Standards Council Decision (Final):	D#11-4
Standards Council Agenda Item:	SC#11-3-15
Date of Decision*:	1 March 2011
<i>TIA No. 1020 on NFPA 654, Standard for the Prevention of Fire and Dust Explosions from the Manufacturing, Processing, and Handling of Combustible Particulate Solids, 2006 edition</i>

Tentative Interim Amendment

NFPA 654

TIA 06-1

Figure A.6.1.1.1 Dust Deflagration Hazard Limitation - Average Layer Depth with Reduced Accumulation Area for Buildings or Rooms less than 20,000 ft²

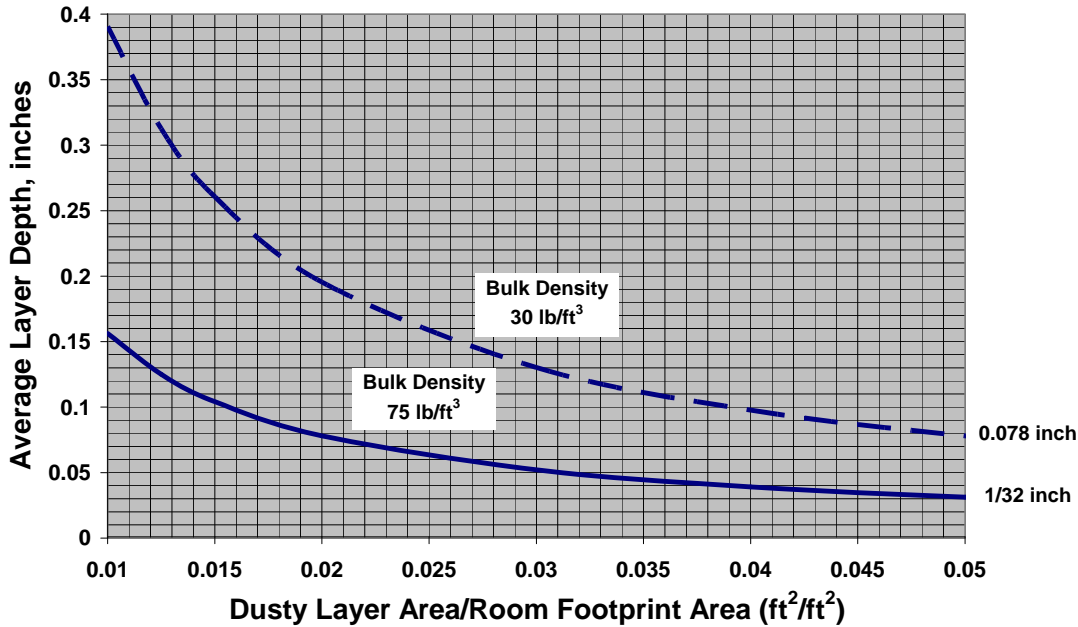
When there is a single accumulation area or the actual layer depth is the same over all accumulation areas, Figure A.6.1.1.3 indicates the actual layer depth which results in a dust deflagration hazard.
